### STAFF RECOMMENDATION 2517 Blair Boulevard March 20, 2019

**Application:** New Construction—Outbuilding, addition  
**District:** Hillsboro-West End Neighborhood Conservation Zoning Overlay  
**Council District:** 18  
**Map and Parcel Number:** 10415002700  
**Applicant:** Blaine Bonadies  
**Project Lead:** Melissa Baldock, melissa.baldock@nashville.gov

**Description of Project:** Application is to construct a half story on top of an existing one-story outbuilding. The existing outbuilding's left facade does not meet the base zoning side setback of five feet (5'). It is between one foot and two feet, eight inches (1' - 2'8") from the left side property line. The outbuilding will not be used as a detached accessory dwelling unit.

Figure 5. The proposed roof form combines a cross gable and large dormers.

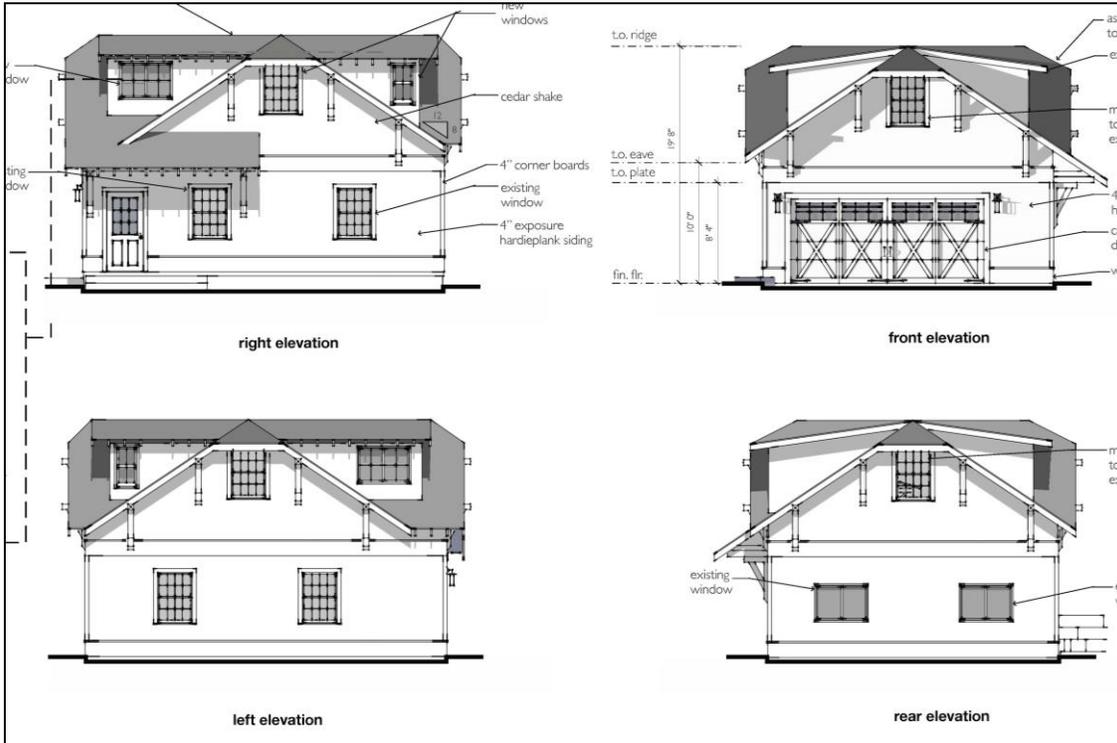
\*The design of the roof combines both dormers and a cross gable form in a manner that has not been approved by the Commission in the past (Figure 5). The design guidelines state that dormers should cover no more than fifty percent (50%) of the roof and should be set back two feet (2') from the wall below. As the roof plan shows, combining the cross gable form with the dormers on either side results in very large dormers that cover almost all of the roof plane (Figure 6). In addition, one dormer on the right elevation, towards the back, is not set back two feet (2') from the wall below, as is required. In the

past, the Commission has generally not approved dormers that attached to a secondary roof plane as historically dormers were typically stand-alone roof features.

Staff finds that the dormers combined with the cross gable form do contrast greatly with the historic house and neighborhood, as it not a typical roof form for the neighborhood for either historic houses or outbuildings. In addition, the combination of dormer and cross gable pushes the scale of roof and the outbuilding to be incompatible with the historic house’s roof form and the design guidelines. Staff therefore finds that the proposed roof form does not meet Section II.B.h. of the design guidelines. Staff recommends that a condition of approval be that the dormers be removed from the cross gable form, or that a simple side gable with dormers that cover no more than fifty-percent (50%) of the roof and that are set back two feet (2’) from the wall below be used.

1. The dormers be removed from the cross gable form, or a simple side gable roof form be used with dormers that cover no more than fifty-percent (50%) of the roof and that are set back two feet (2') from the wall below;
2. Staff approve all windows and doors prior to purchase and installation.
